Pre-Application Briefing to Committee

Reference No: PPA/2021/0019

Address: Highgate School North Road London N6 4AY

Figure 17: Proposed North Elevation Dyne House

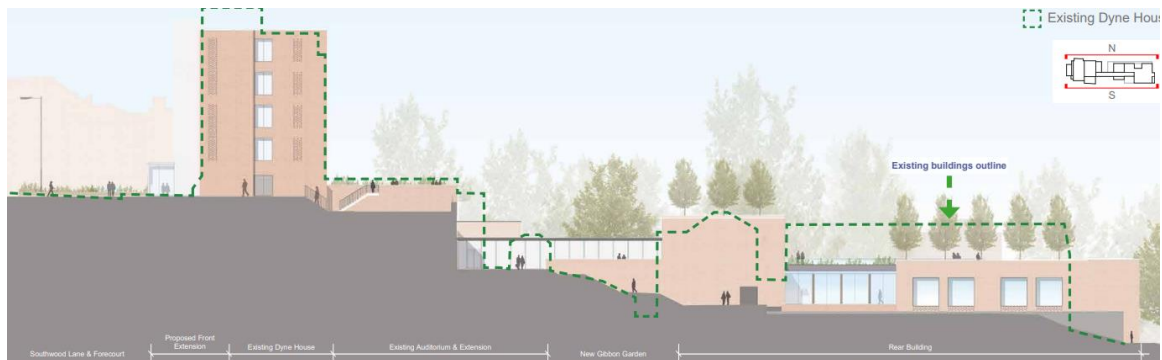
be acceptable. The land levels drop away significantly to the rear of Dyne House. It is proposed to construct the replacement rear buildings into these dropping land levels. The elevation drawing at figure 12 indicates that the replacement buildings would not be notably larger in terms of height, when compared with the existing buildings. The form and materials of the replacement buildings appear to be complementary to the main Dyne House building. The proposed new MUGA at the very rear of the site could be acceptable in design terms although further details will be required to ensure it is visually compatible with the other proposals on the site and to demonstrate how it addresses Core Objective 4 of the Neighbourhood Plan regarding greening the Parade Ground area.

Figure 20: Existing and proposed massing of the RMC

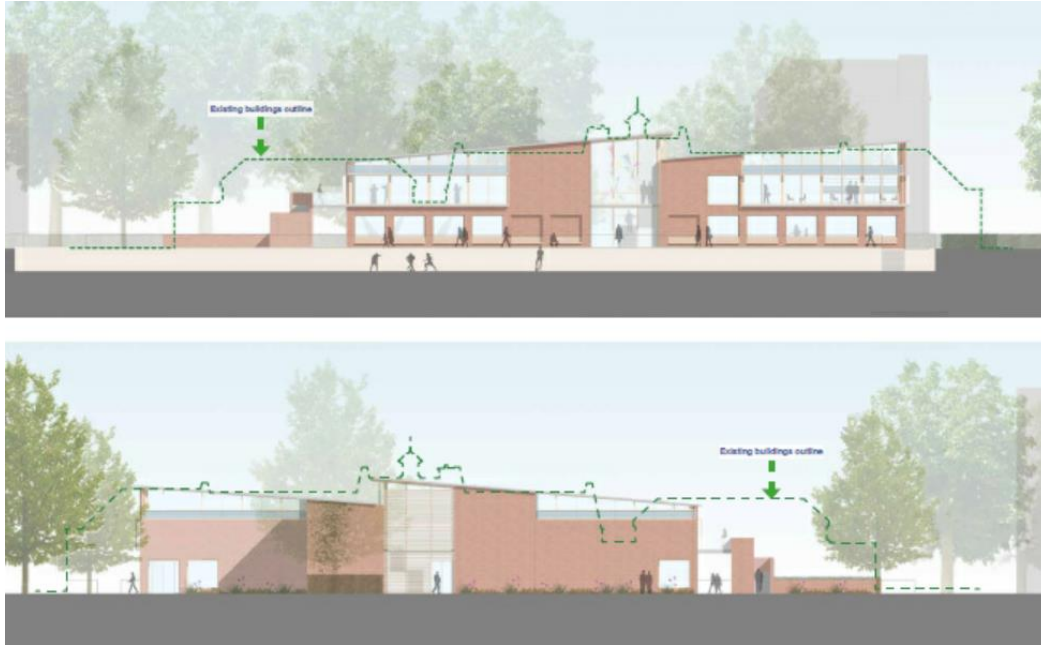
7.41. The re-development of the RMC building is proposed to follow a similar footprint. However, the location of the proposed building would be improved by being pulled away from the residential neighbour at its rear. The new building would be of similar height but with reduced bulk to its rear.
